NSD-NRC-96-4719
DCP/NRC0512
Docket No.: STN-52-003

SUBJECT: WESTINGHOUSE RESPONSES TO NRC REQUESTS FOR ADDITIONAL
INFORMATION ON THE AP600

Re: WCAP-14234 (LOFTRAN CAD)

Figure 440.276-1: Schematic of Secondary System

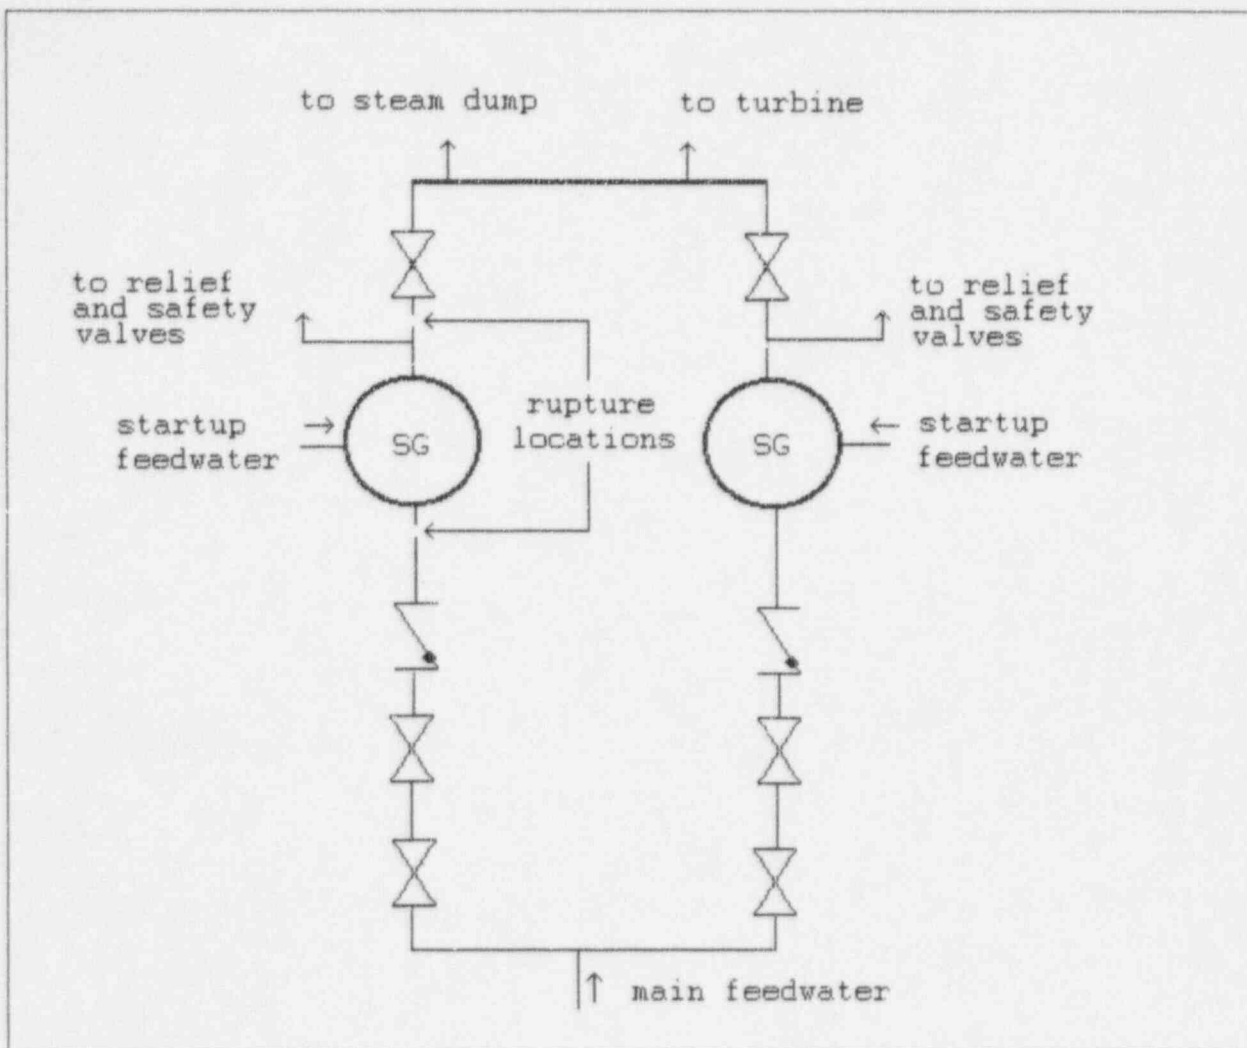
Please clarify whether double ended steam and feedline breaks are modelled with LOFTRAN for the AP-600 applications. Please provide the nodding arrangements and discharge coefficients for modelling these breaks.

For the steam system piping failure event (SSAR Section 15.1.5) and the feedwater system pipe break event (SSAR Section 15.2.8) double-ended ruptures are modelled. The secondary side of the steam generator is represented by a single node. A simplified schematic of the secondary system is shown in Figure 440.276-1. In LOFTRAN, pipe breaks are not modelled using discharge coefficients. The Moody critical flow model (Reference 440.276-1) with no friction losses is used for the computation of break flow. The double-ended break flow areas for the steam system piping failure and the feedwater system pipe break are 1.4 square feet and 1.12 square feet, respectively.
